STAFF REPORT

COMMUNITY DEVELOPMENT DEPARTMENT

HEARING DATE: May 18, 2021
(Continued from: February 23 and April 13, 2021)

SUBJECT: H-2020-0047
Prescott Ridge – AZ, PP, PS, ~~ALT~~

A. Master Plan Conceptual Rendering & Medical Campus Conceptual Development Plan - REVISED

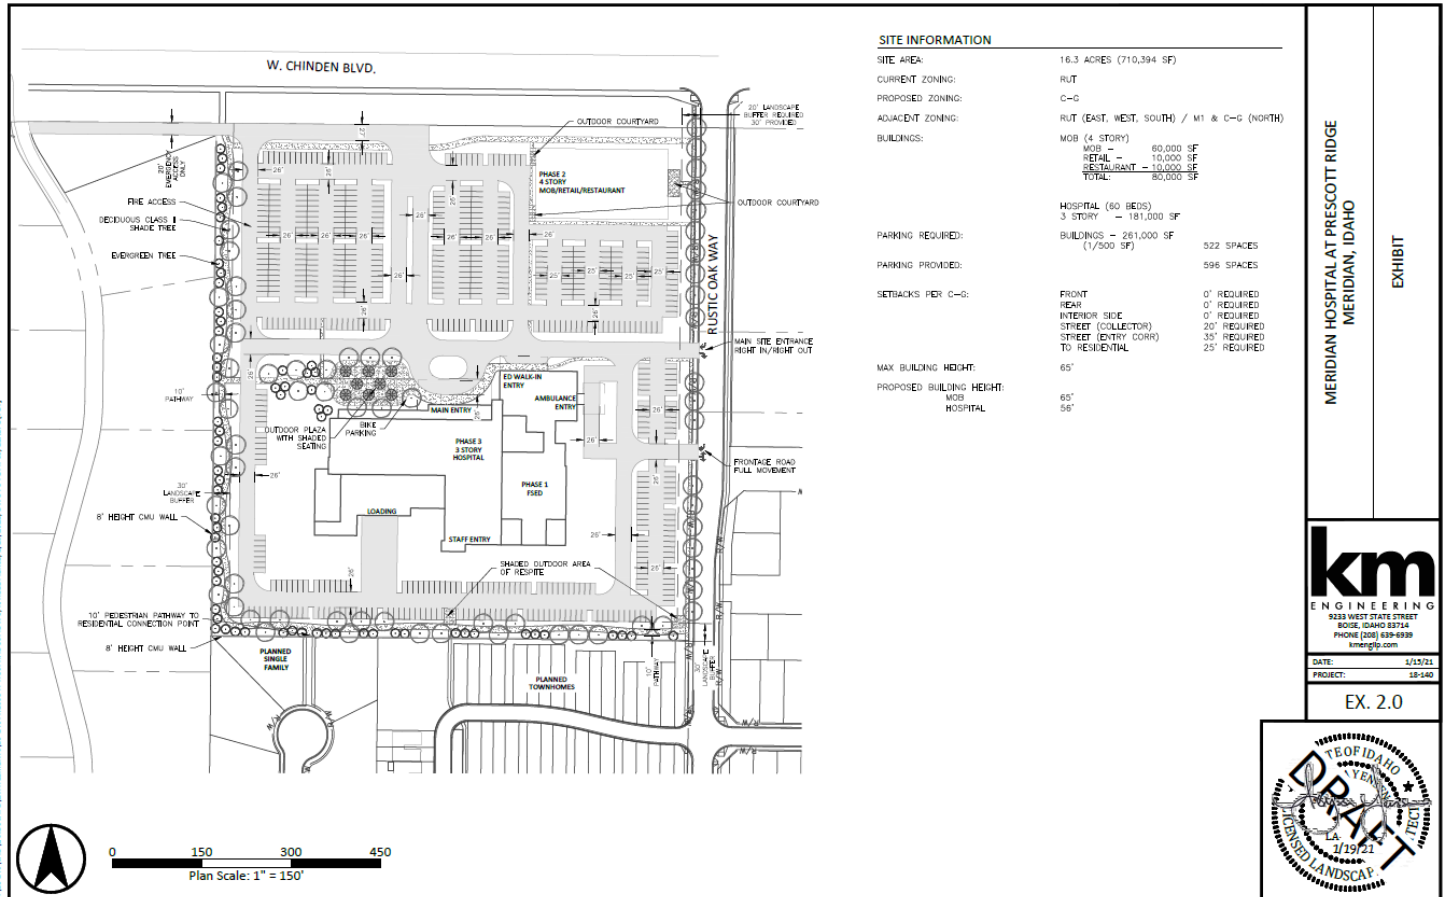
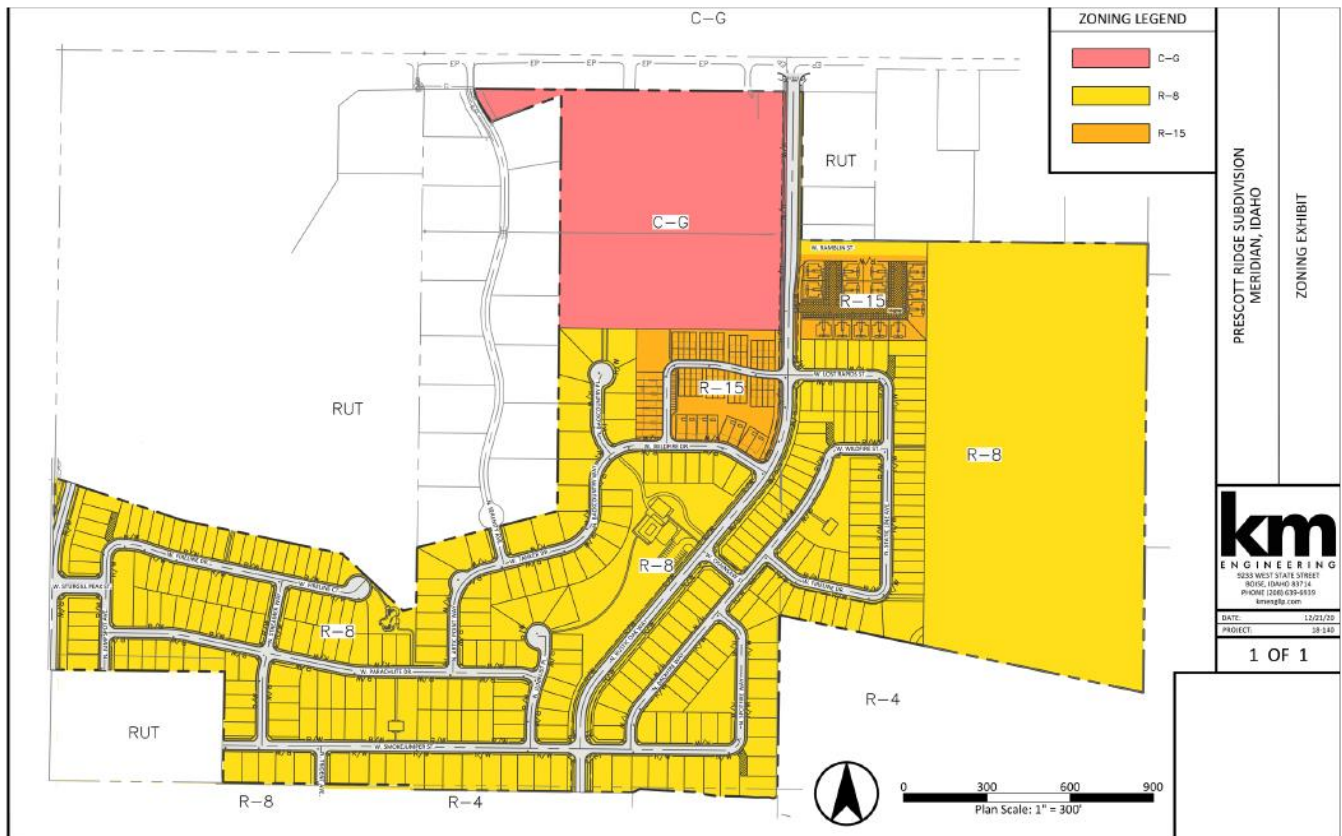
- b. Relocate the parking on the east side of the medical office building to the west side of the building and shift the building further to the east away from the adjacent residential properties (see revised concept plans in Section VIII.A);

Note: Although tree-lined trees are depicted, parkways with detached sidewalks are not proposed except for along the collector streets (i.e. N. Rustic Oak Way & McDermott Rd.) and on common lot end-caps; an east/west-oriented meadow with landscaping is depicted within the townhome portion of the development which is also not proposed.

5. A frontage road parallel to W. Chinden Blvd./SH 20-26 shall be constructed as depicted on the conceptual development plan in Section VIII.A in accord with UDC 11-3H-4B.3e.

9. The buffer along the west boundary of the site shall incorporate a 2-foot tall berm with an 8-foot tall wall on top of the berm to assist in blocking the noise from the commercial development if approved by the Peregrine Heights Homeowner's Association (HOA). If not approved by the HOA, the landscaping and wall shall be installed as depicted on the conceptual development plan.

C. Preliminary Plat (date: ~~8/28/2020~~ 10/21/20 ~~11/20/20~~ 12/22/20), Phasing Plan & Lot Layout Exhibit REVISED

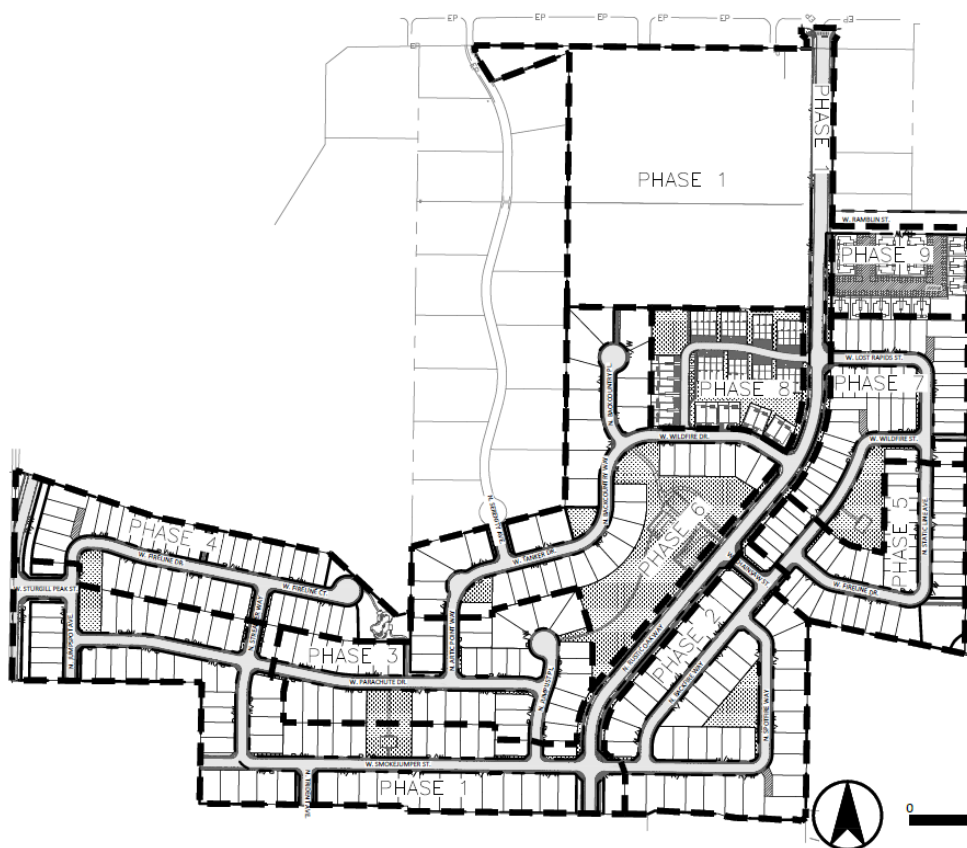
- d. Reduce the number of lots along the southern boundary to provide better transition to the R-4 properties planned to the south in The Oaks subdivision (lots were reduced by 5 along the south and southeast boundaries, see revised plat in Section VIII.C).

- b. ~~Remove Lot 1, Block 15 as it's ACHD right of way and cannot be platted as a common lot.~~
 - c. Depict cross-access/ingress-egress easements to adjacent MU-R designated properties to the west (Parcels # R6991221700 & R6991221600) and east (Parcel # R6991222101) in accord with UDC 11-3A-3A.2.

- e. Depict the easement(s) for the West Tap sub-lateral; if the easement(s) is greater than 10-feet in width, it should be placed in a common lot that is a minimum of 20-feet in width and outside of a fenced area, unless modified by City Council as set forth in UDC 11-3A-6E.

- g. Lots 70-83, Block 12 in the multi-family portion of the development shall be revised to depict parking and access driveways on a common lot with an ingress-egress/parking easement for each buildable lot. **A revised plat shall be submitted at least 10 days prior to the City Council hearing depicting this change.** *Done*

- h. Extend W. Smokejumper St. as a stub street to the out-parcel (Parcel #S0428233620) at the southwest corner of the site.
3. The landscape plan submitted with the final plat application shall be revised as follows:

D. Landscape Plan (date: ~~8/26/2020~~ 10/9/2020 ~~11/19/20~~ 12/22/20) – REVISED

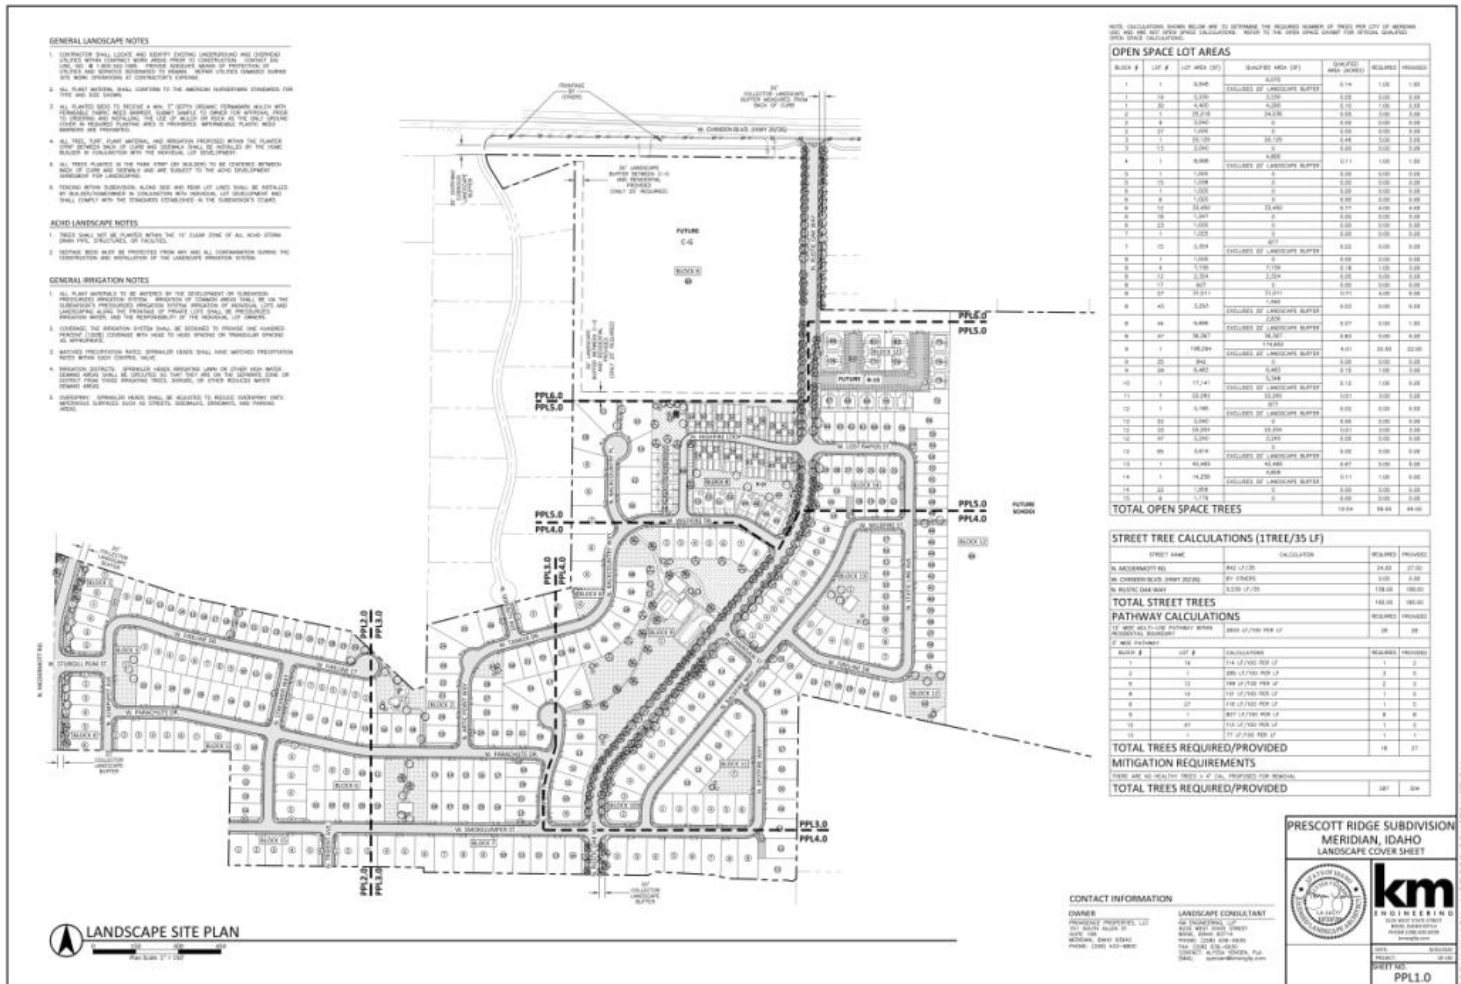
Parkways where provided are required to be landscaped in accord with the standards listed in [UDC 11-3B-7C](#). **The total linear feet of parkways with the required and proposed number of trees should be included in the Landscape Calculations table on the final plat landscape plan to demonstrate compliance with the required standards.**

Landscaping is required along all pathways in accord with the standards listed in [UDC 11-3B-12C](#). **The total lineal feet of pathways with the required and proposed number of trees should be included in the Landscape Calculations table on the final plat landscape plan to demonstrate compliance with UDC standards.**

Common open space is required to be landscaped in accord with the standards listed in [UDC 11-3G-3E](#). **The total square footage of common open space with the required and proposed number of trees should be included in the Landscape Calculations table on the final plat landscape plan to demonstrate compliance with the UDC standards.**

Noise abatement is required to be provided in the form of a berm or a berm and wall combination parallel to W. Chinden Blvd./SH 20-26 constructed in accord with the standards listed in UDC 11-3H-4D. **A detail/cross-section of the proposed noise abatement should be submitted with the final plat application for the commercial portion of the development that demonstrates compliance with the required standards.**

- a. Depict a detail/cross-section of the berm or berm and wall combination required as noise abatement within the street buffer along W. Chinden Blvd./SH 20-26 and N. McDermott Rd.; also address how the wall will be constructed to avoid a monotonous wall, that demonstrates compliance with the standards listed in UDC 11-3H-4D.

- ~~b. Remove Lot 1, Block 15 as it's ACHD right of way and cannot be platted as a common lot.~~
 - c. Depict a detached sidewalk/pathway (as applicable) along all collector streets (i.e. N. McDermott Rd., N. Rustic Oak Way and W. Ramblin St.) and W. Chinden Blvd./SH 20-26 in accord with UDC 11-3A-17. *A detached 10-foot wide multi-use pathway is required within the street buffers along N. McDermott Rd., W. Chinden Blvd./SH 20-26, the east side of N. Rustic Oak Way and W. Ramblin St.*

G. Conceptual Building Elevations/Perspectives - REVISED

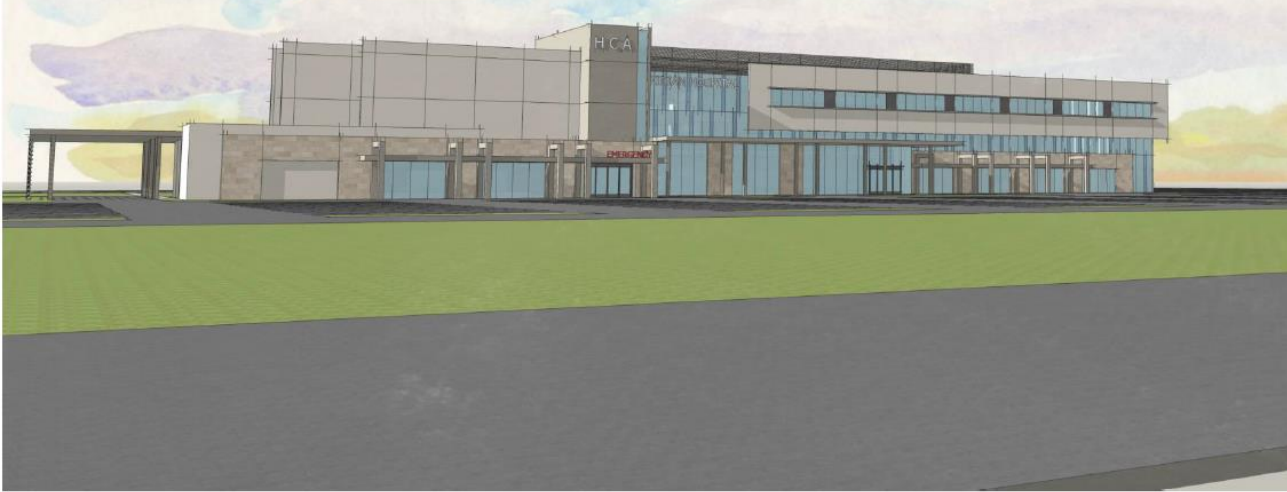
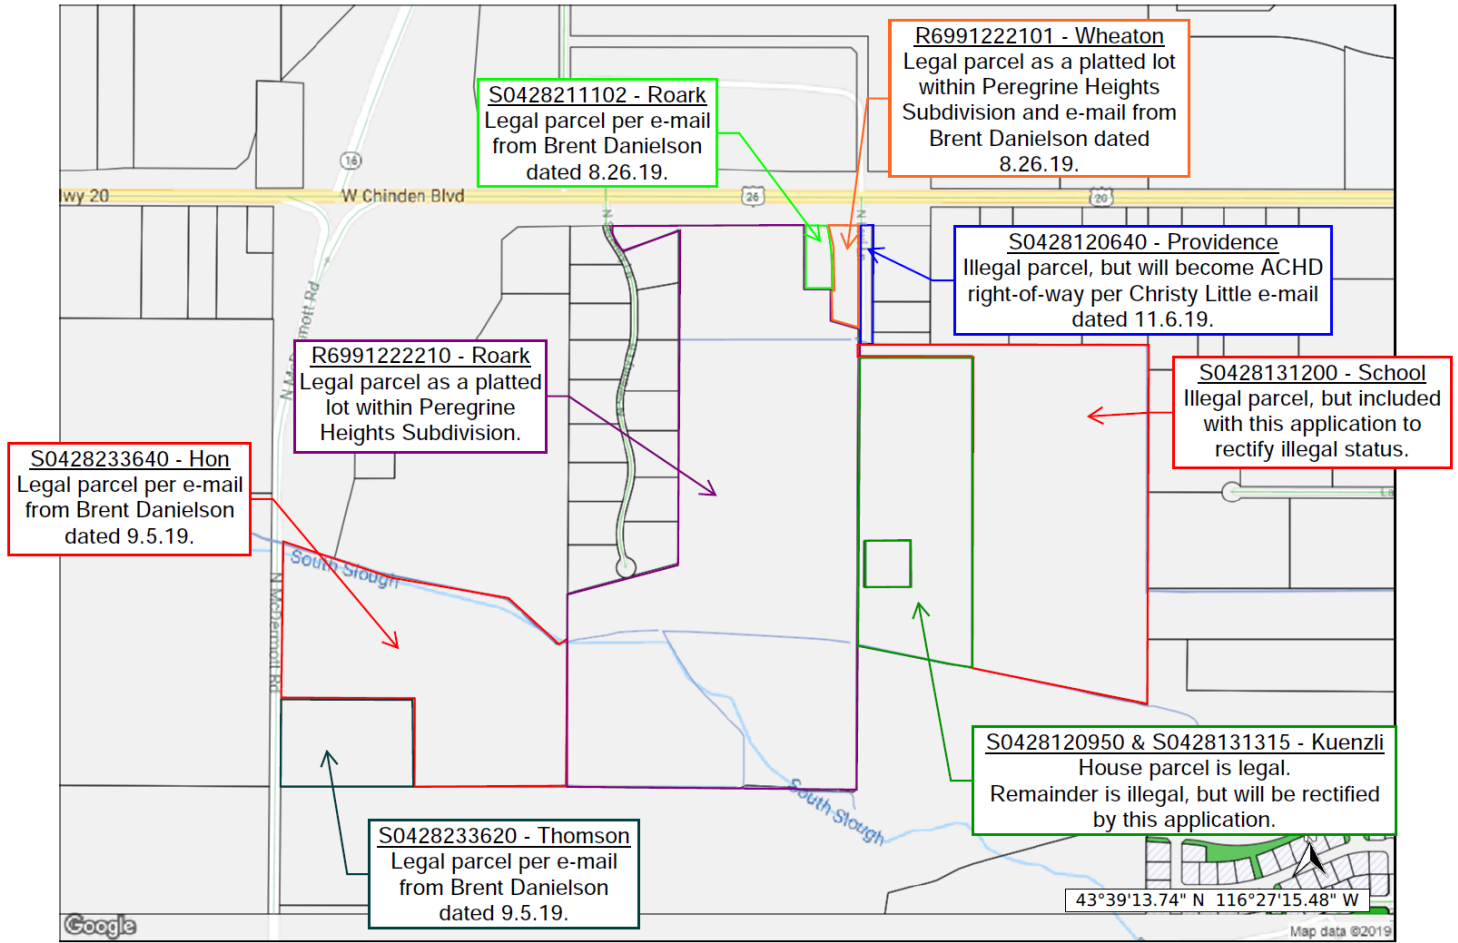
Because the side and/or rear of 2-story homes that face collector streets (i.e. N. McDermott Rd., N. Rustic Oak Way and W. Ramblin St.) will be highly visible, these elevations, should incorporate articulation through changes in two or more of the following: modulation (e.g. projections, recesses, step-backs, pop-outs), bays, banding, porches, balconies, material types, or other integrated architectural elements to break up monotonous wall planes and roof lines that are visible from the subject public street. *Single-story structures are exempt from this requirement.*

Conceptual renderings of the hospital and medical office buildings were submitted as shown in Section VIII.G. The hospital is proposed to be a 3-story building and the medical office building a 4-story building. **The elevations for the medical office building incorrectly depict a 3-story building; these elevations should be revised prior to the City Council hearing to reflect the correct number of stories.**
